Subject: Final Determination of Effect, Stipulation 11 of the 2012 Memorandum of Agreement (Updated since May 8, 2015)

EISENHOWER MEMORIAL

REVISED PRELIMINARY AND FINAL DESIGN SUBMISSION

SUBMISSION DATE: SEPTEMBER 1, 2017

PROPOSED ART FOR THE TAPESTRY WITH PANELS SHOWING MOCKUP LOCATION

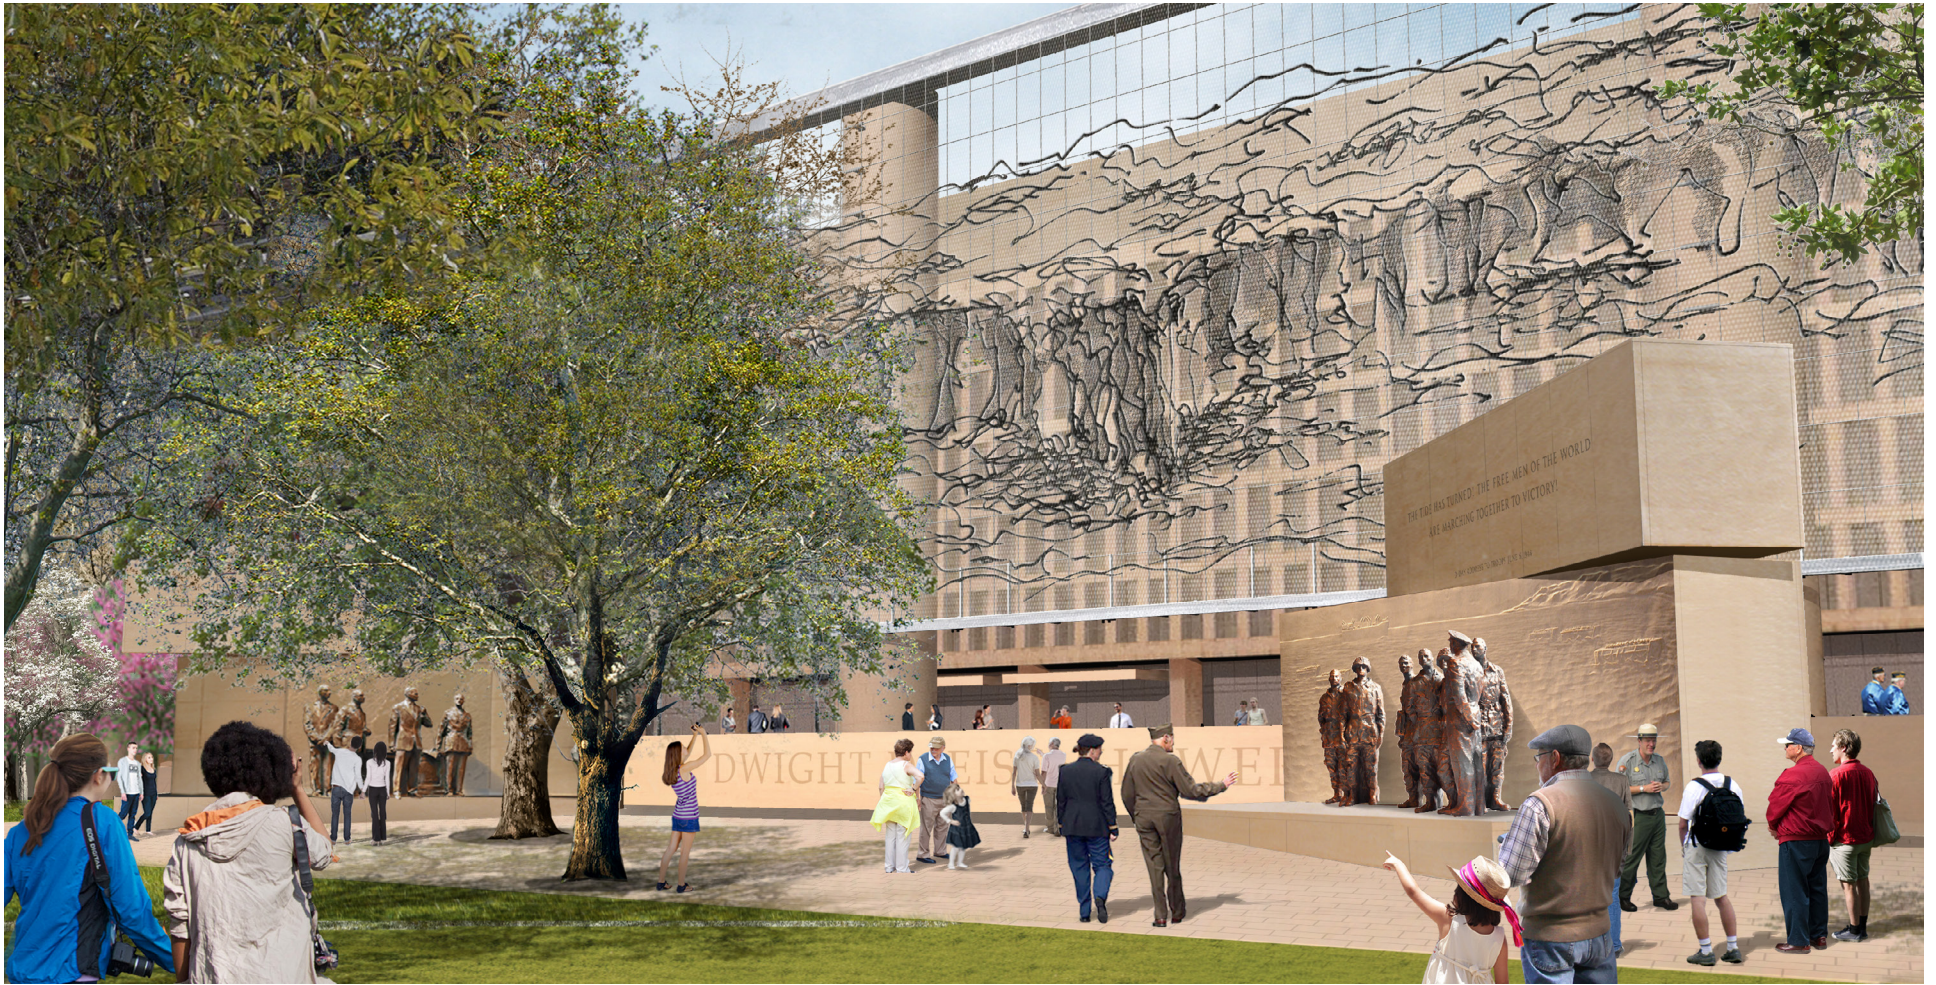
After further study and review of the previous tapestry mockups, the team concluded that a graphic approach to the Normandy landscape art with higher contrast would be more successful for improving image clarity against the backdrop of the Lyndon B. Johnson building. The revised design is an artistic drawing of the cliffs of Normandy coastline that will increase legibility and the transparency of the overall tapestry.

YOUNG EISENHOWER STATUE

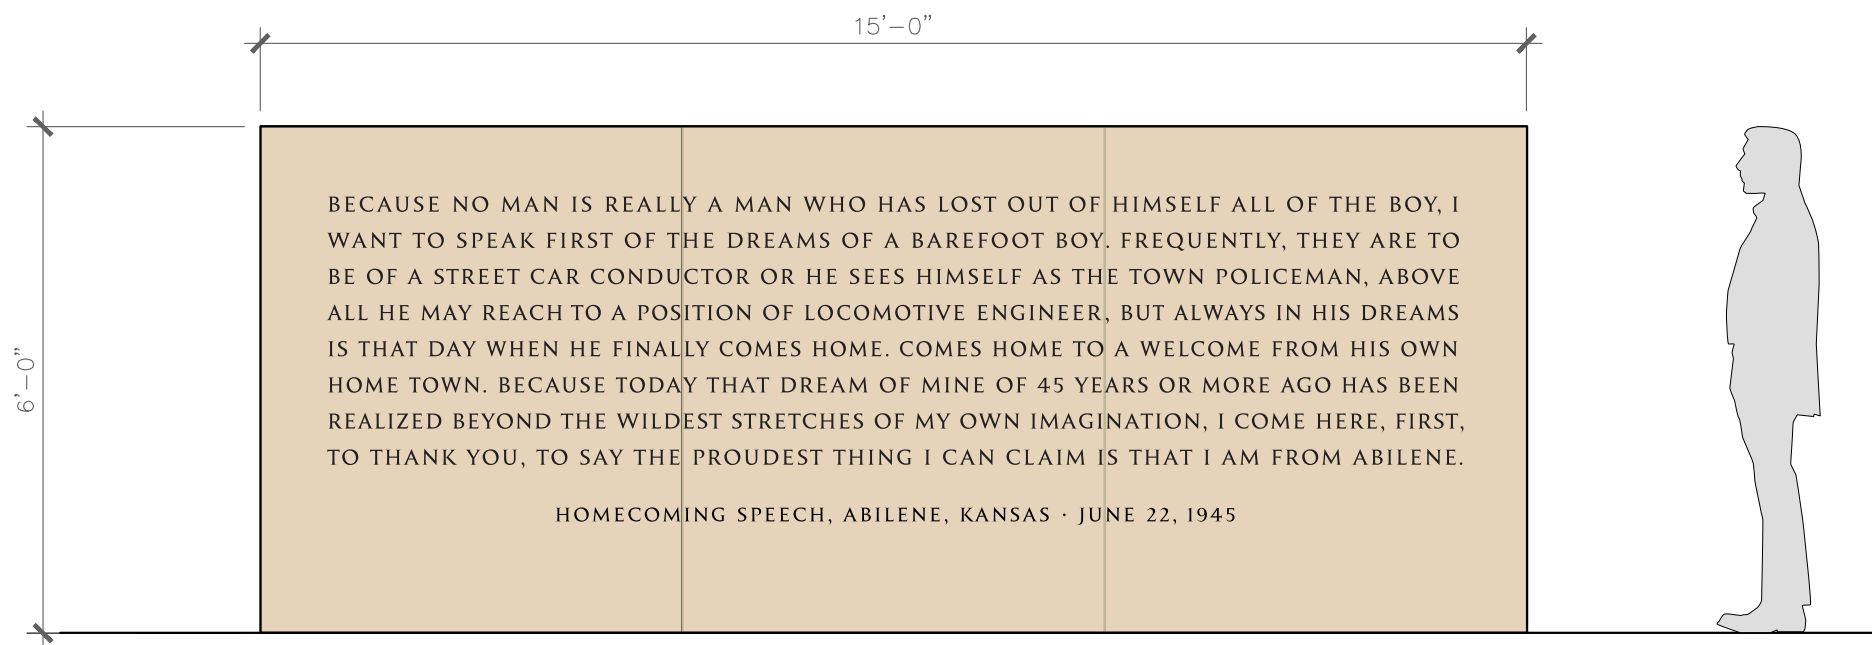
The statue of Eisenhower as a young man has been repositioned and refined in response to the CFA and NCPC Commission comments.

The statue is now located at the Northwest plaza entrance into the Memorial. The artist has refined the sculpture pose, with the figure seated on a podium. Adjacent to the statue, on the south edge of the plaza, is an inscription wall with an excerpt from the Homecoming speech that Eisenhower gave upon his return to Abilene in 1945. In this speech, Eisenhower's references his strong connection with his hometown of Abilene, Kansas.

The pose of Young Eisenhower has been refined by the sculptor. The maquette shows the figure seated on a limestone pedestal that is 30" high. The figure looks toward the Memorial. The youthful Eisenhower offers a counter point to the General and Presidential portrait figures depicting more serious moments in Eisenhower's life.

CANOPY TREE PLAN

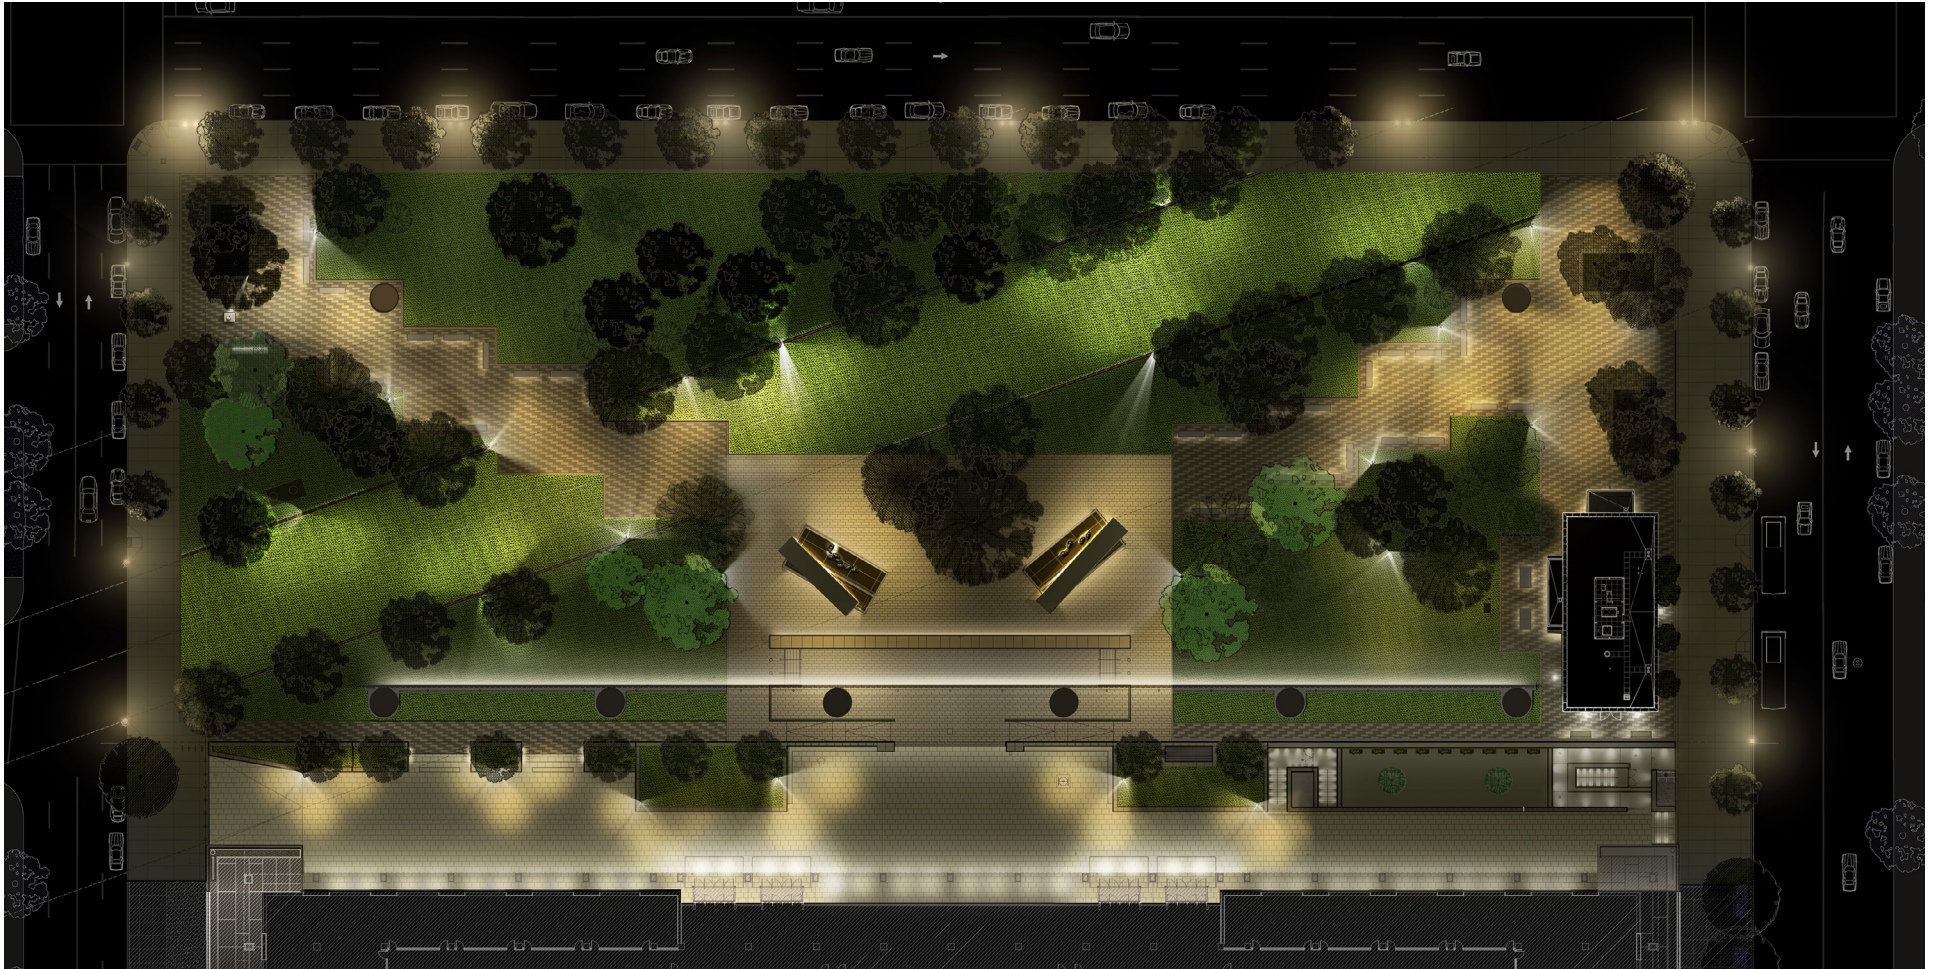
The landscape planting plan has returned to the previously approved 2015 design. In February 2017, the team proposed the removal of four trees adjacent to the Memorial core to increase views to the tapestry. The tree removal has been reconsidered, and is no longer being proposed. The current design proposes a species revision at the memorial core center tree from a London Plane to a Bur Oak to give the central grove of trees a stronger character and presence. Additionally, an existing street tree originally proposed to remain on Sixth Street, SW, is being replaced with a Swamp White Oak in the current design to match the other proposed street trees along the west edge of the memorial. The existing tree is being removed from the project due to the poor health of the tree.

CURRENT RENDERED LIGHTING PLAN

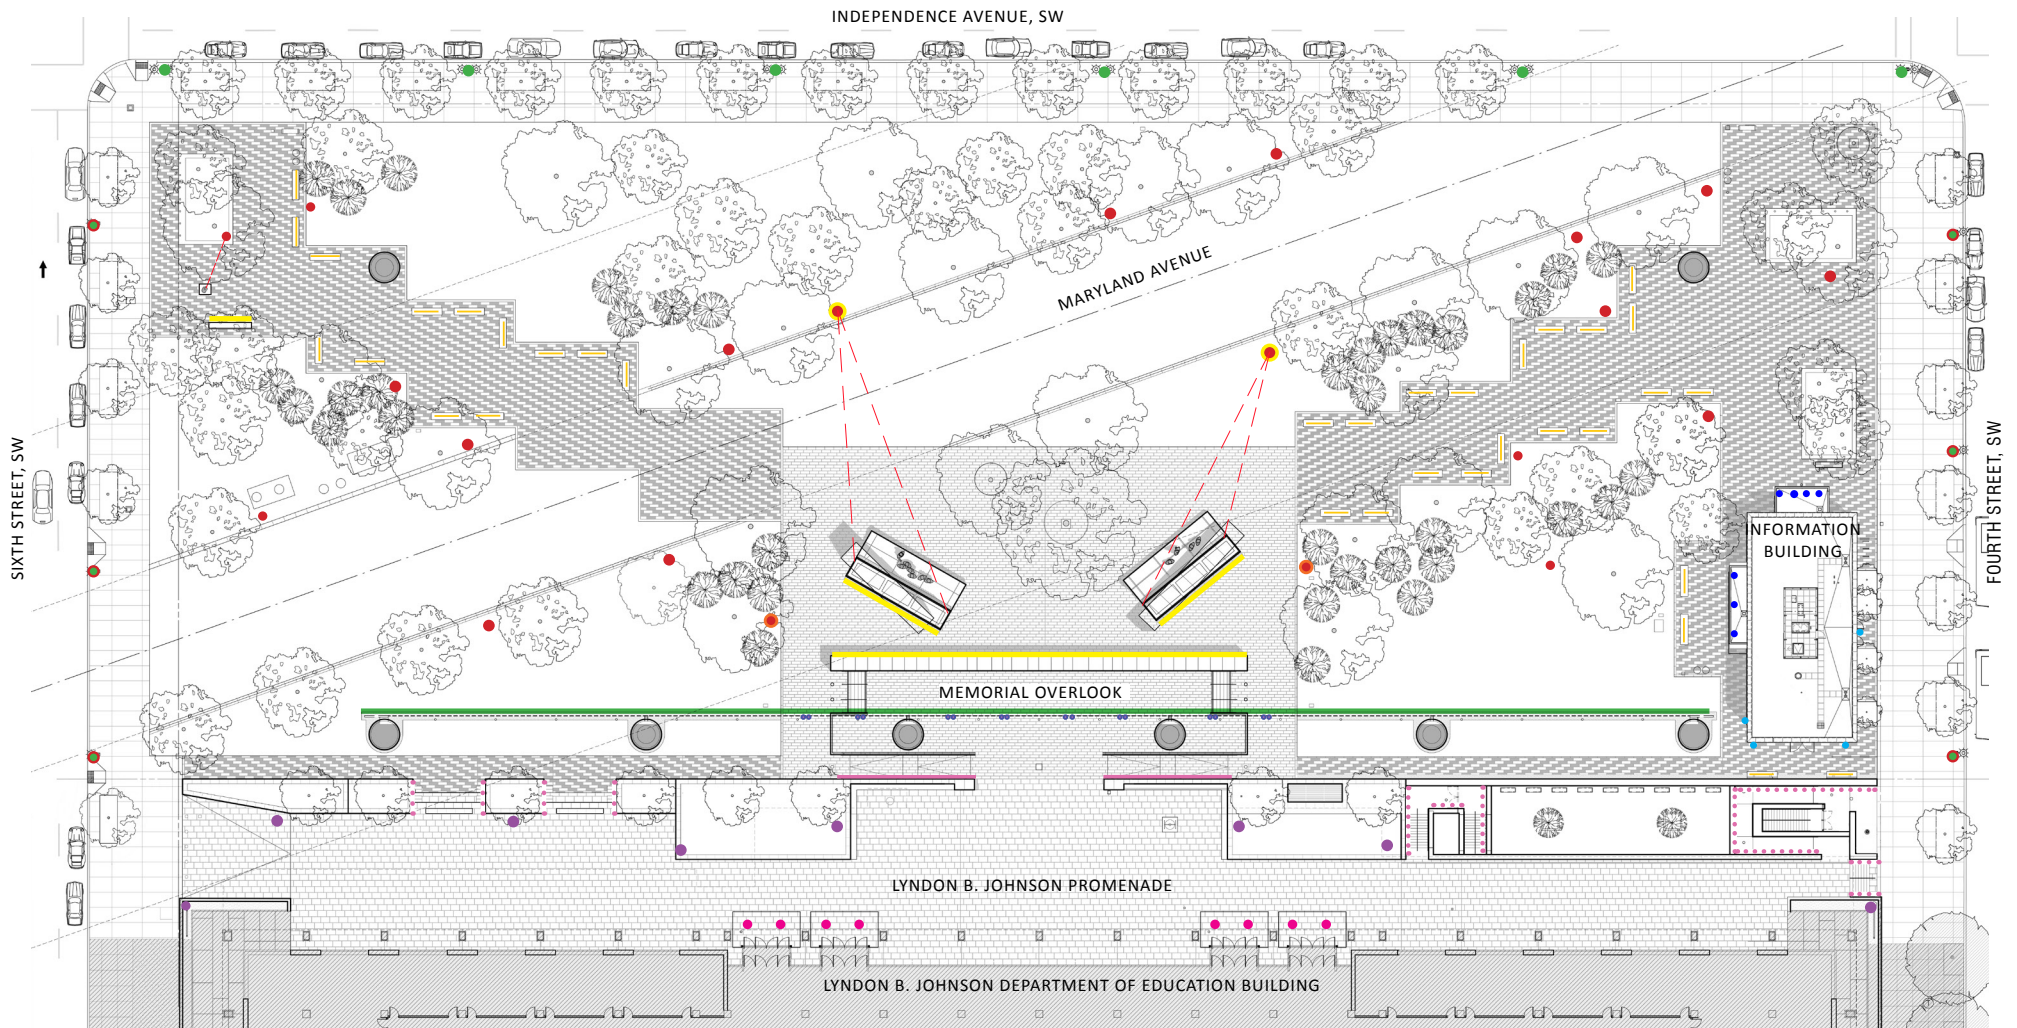
The lighting plan is the same as the previously approved design with the addition of lighting for the sculpture of Eisenhower as a young man and the new inscription wall at the Northwest Entry Plaza.
